Docket Item #4 A-D
Master Plan Amendment #2011-0007
Rezoning #2011-0001
Development Special Use Permit #2011-0015
Special Use Permit/Transportation Management Plan #2011-0060

<u>Application</u>	<u>General Data</u>	
<u>Project Name:</u> Safeway on King Street	PC Hearing:	November 1, 2011
	CC Hearing:	November 12, 2011
	If approved, DSUP Expiration:	November 12, 2014 (three years)
<u>Location:</u> 3526 King Street	Zone:	Existing: CG/Commercial General Proposed: OC/Office Commercial with proffer
	Proposed Use:	Retail
<u>Applicant:</u> Safeway, Inc., represented by Duncan Blair	Small Area Plan:	Fairlington/Bradlee
	Historic District:	Not Applicable
	Green Building:	LEED Silver Certification for New Construction

MPA#2011-0007, REZ#2011-0001
DSUP#2011-0015, TMP SUP#2011-0060
Safeway, Inc., 3526 King Street

Existing Map 3 in Fairlington/Bradlee Small Area Plan

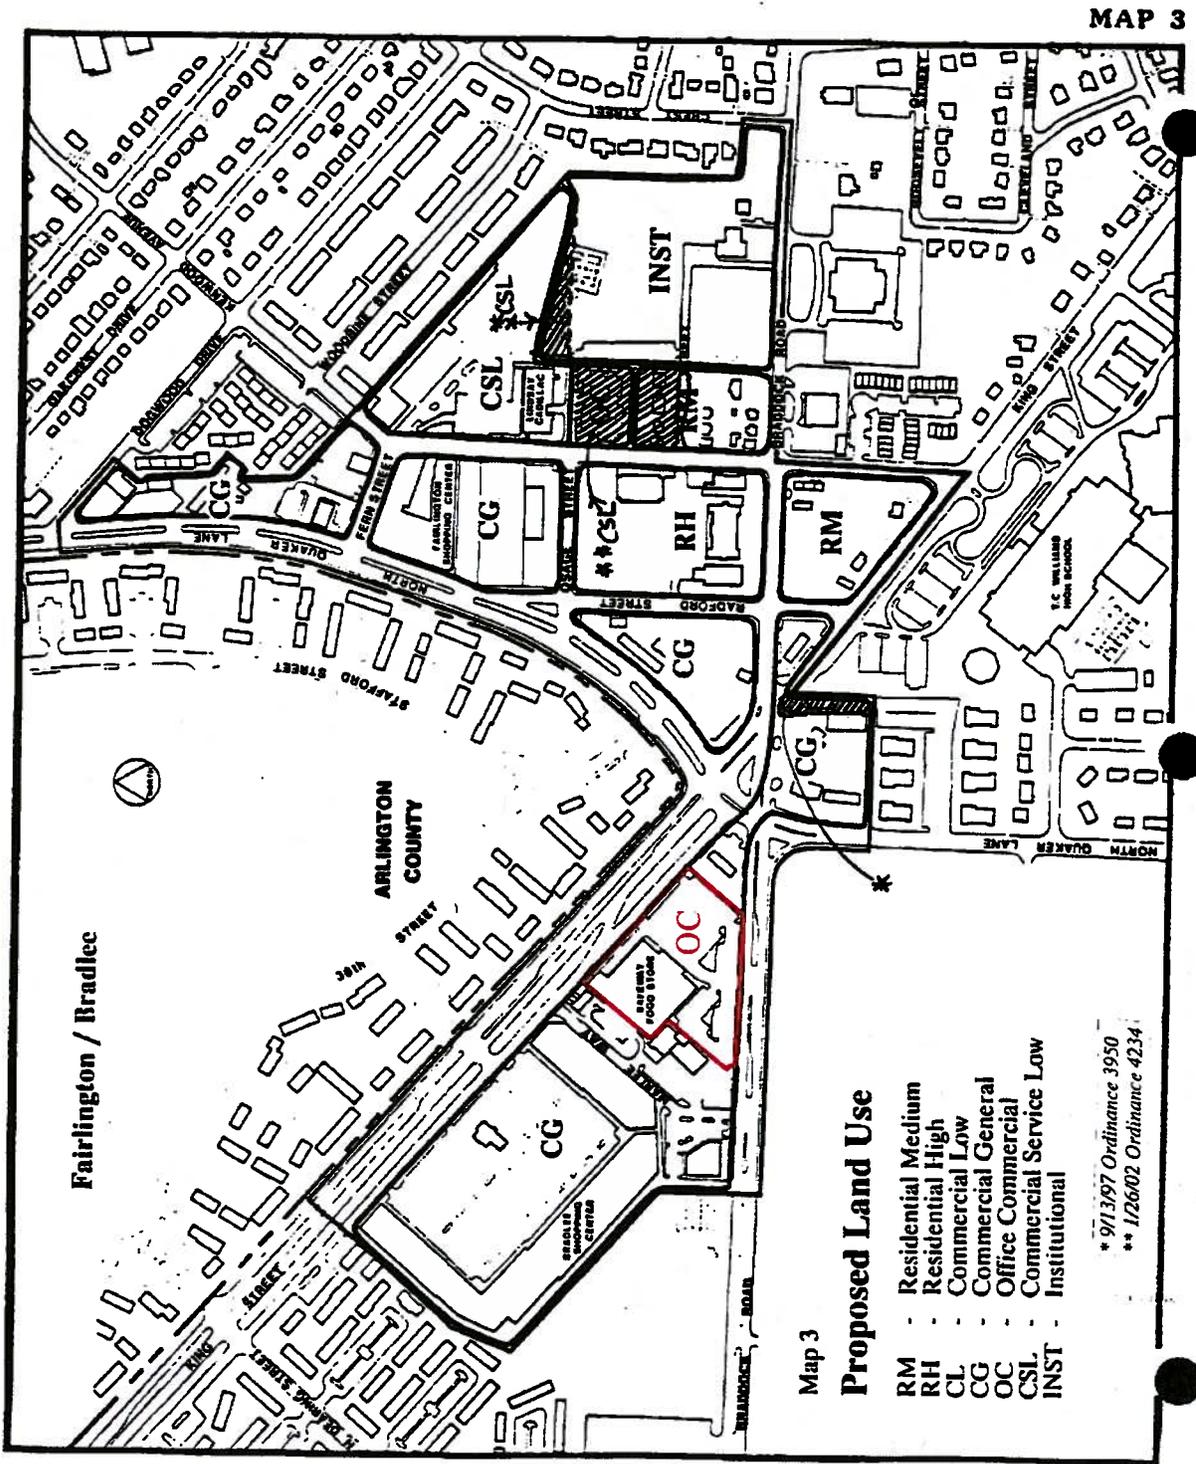
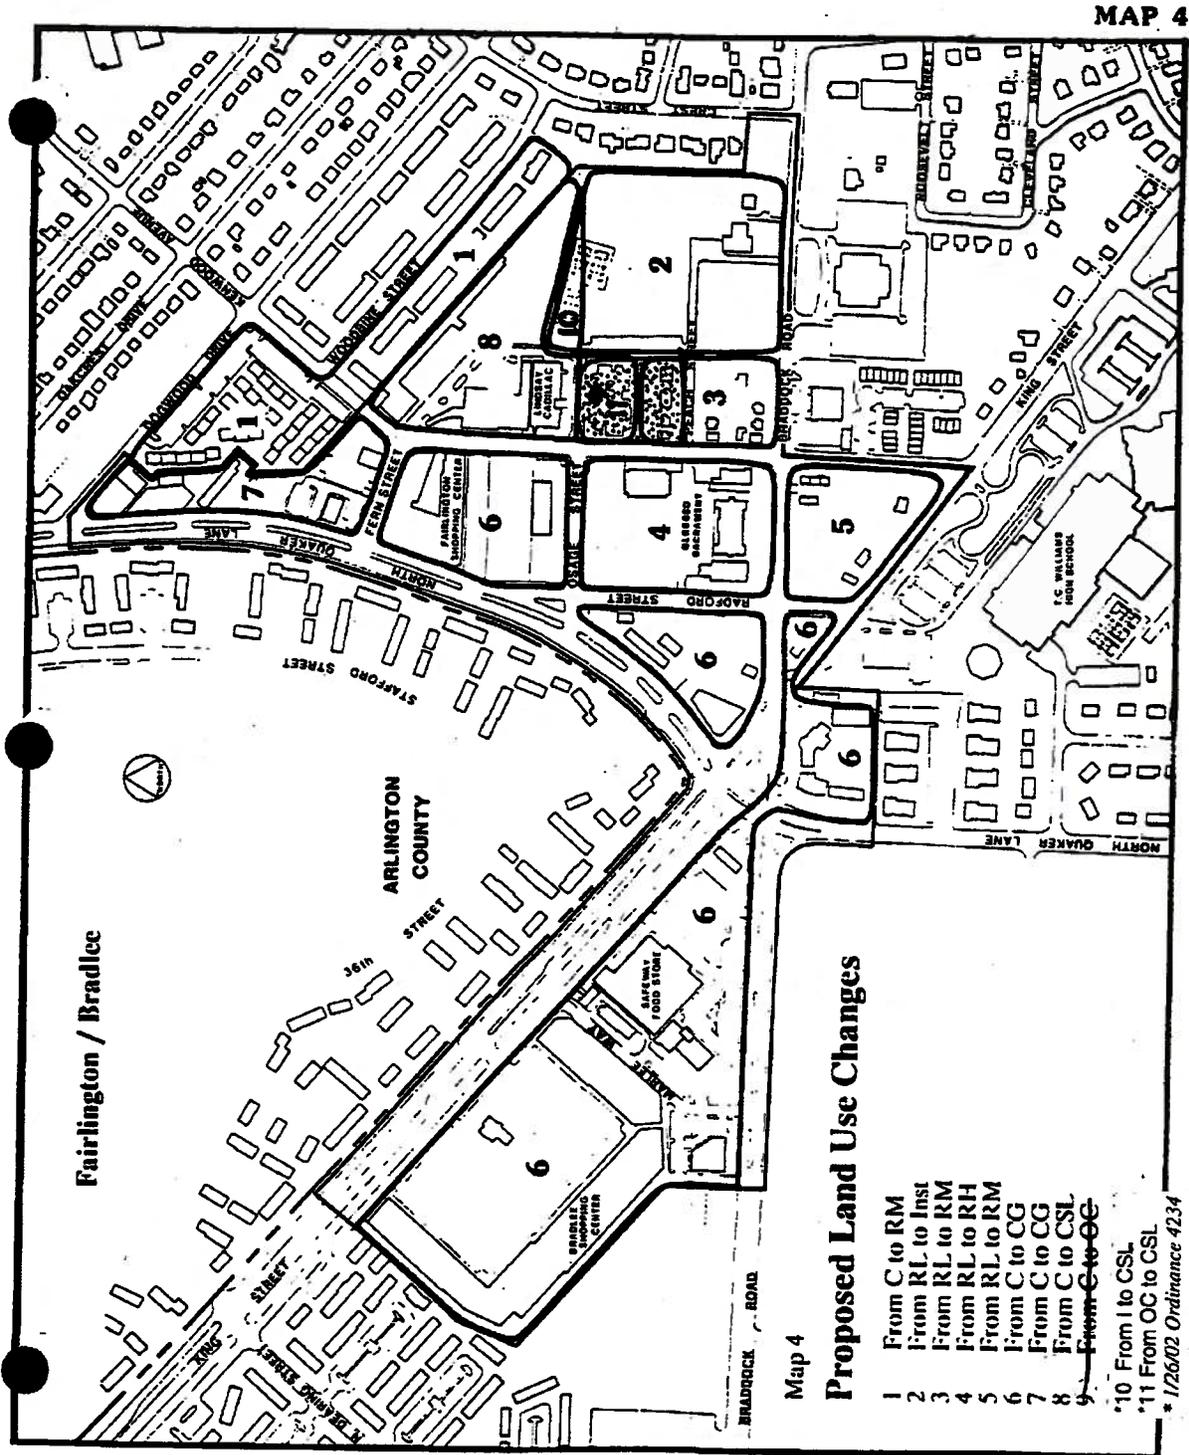
ATTACHMENT #3 – Map Adjustments to Small Area Plan

Proposed Map 3 for Fairlington/Bradlee Small Area Plan
